# ZF 6HP19A

## TECHNICAL INFORMATION BULLETIN

# ZF 6HP19 & 6HP19A Fitted to BMW, VW & Audi

### 6HP19.HUB01 Modified Intermediate Shaft

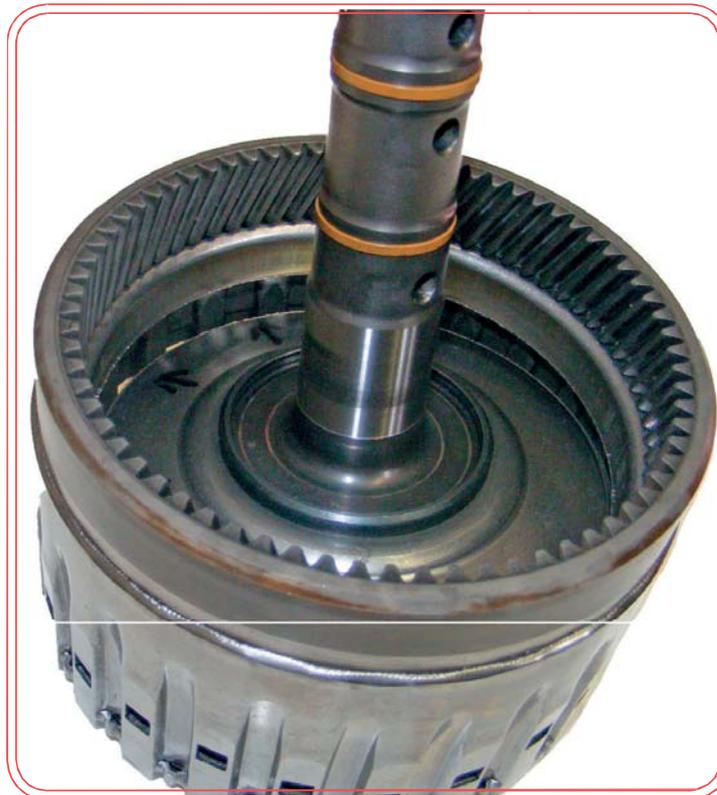
Flare into fourth, no upshift into fourth, if throttle is released the transmission engages fourth OK and once in fourth will drive without problem on all throttle settings.

It not uncommon for the 'E' clutch drum assembly to crack around the inner circumference of 'E' clutch piston bore, this can be seen more readily from the annulus side of the drum as shown in the illustration below. We believe this is due to the constant flexing at this point caused by the planetary sun gears driving the annulus back and fourth during drive and overrun conditions, this gradually over time creates a stress fracture. The reason that once fourth has engaged all seems well is that when the throttle is released the annulus is drawn forward on overrun, closing the crack and allowing pressure to build up behind the piston, this pressure then further reinforces the closure of the crack keeping the clutch fully engaged, giving the impression that all is now well within the clutch.

In this illustration the crack has been opened up to emphasise the area to examine, it is quite often very difficult to see, so very careful examination is necessary
